Alterations to School District Facilities – Phase Two
Peekskill City School District
APN 1901.2

ADDENDUM No. 3

4 March, 2021

Drawing Number:
PH 301

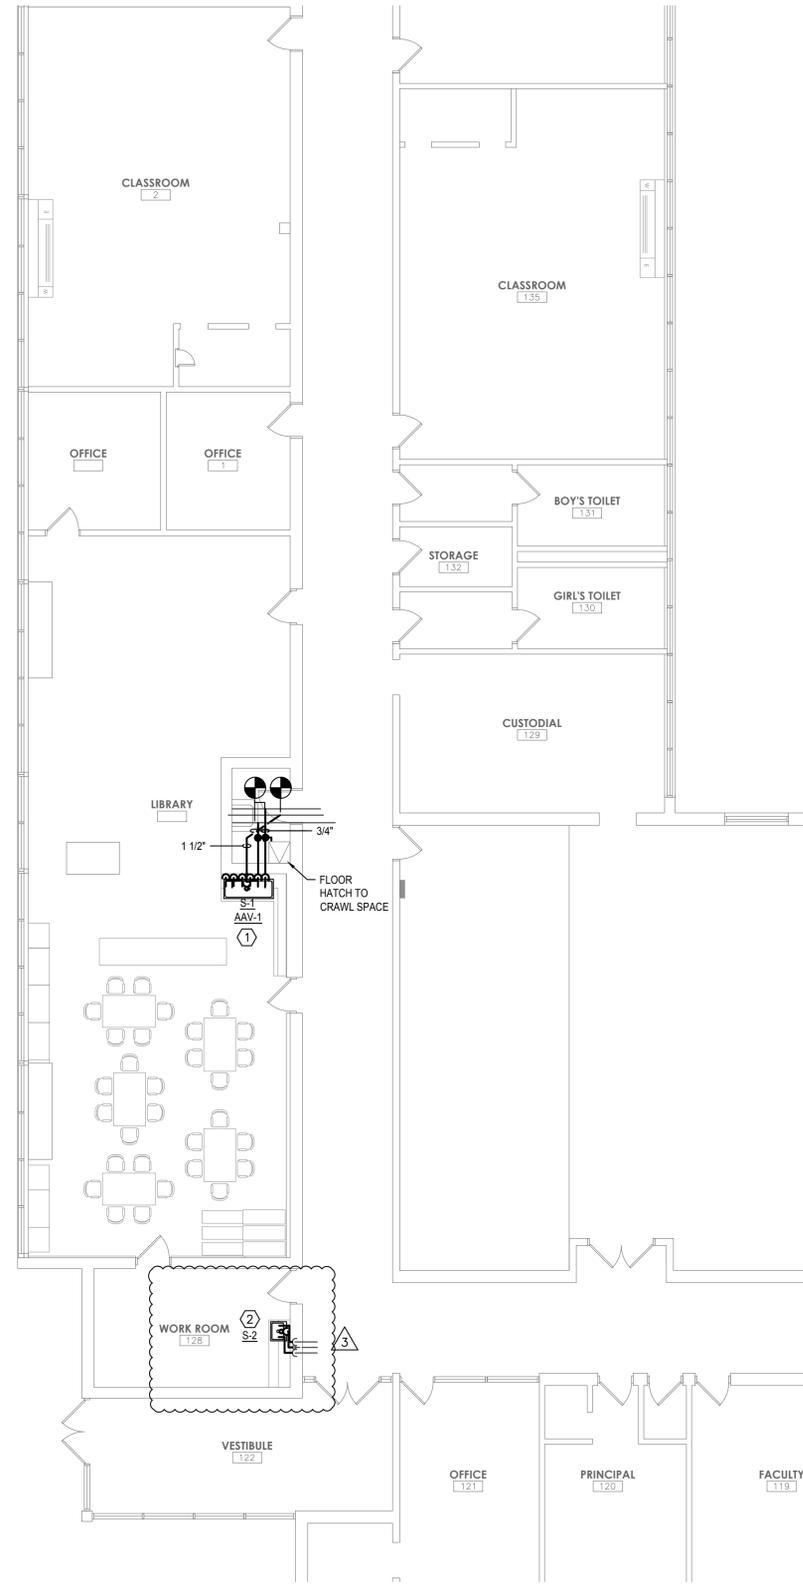
5. SHEET PH 301 – NEW PLUMBING PLAN
 - a. OMIT sheet and replace with revised sheet.

1. PROVIDE NEW WASH SINK AS SCHEDULED. PROVIDE NEW COLD WATER AND HOT WATER TO FAUCETS. LOCATE WATER LINES IN CRAWL SPACE BELOW. ACCESS TO CRAWL SPACE IS THROUGH AN ACCESS HATCH IN THE ADJACENT JANITORS CLOSET. PROVIDE NEW 1 1/2" DRAIN WITH AIR ADMITTANCE VALVE FOR SINK. LOCATE AND CONNECT TO EXISTING DRAIN LINE FROM JANITORS CLOSET IN CRAWL SPACE BELOW.
2. REMOVE THE EXISTING SINK BASIN, FAUCET, STOPS SUPPLIES P-TRAP AND WASTE OUTLET PIPING TO THE WALL. PROVIDE NEW SINK AS SPECIFIED. CONNECT NEW CW,HW AND WASTE PIPING TO THE EXISTING ROUGHING FROM THE ORIGINAL SINK. MODIFY THE ROUGHING AS REQUIRED. PROVIDE CUTTING AND PATCHING OF THE WALL TO MATCH.
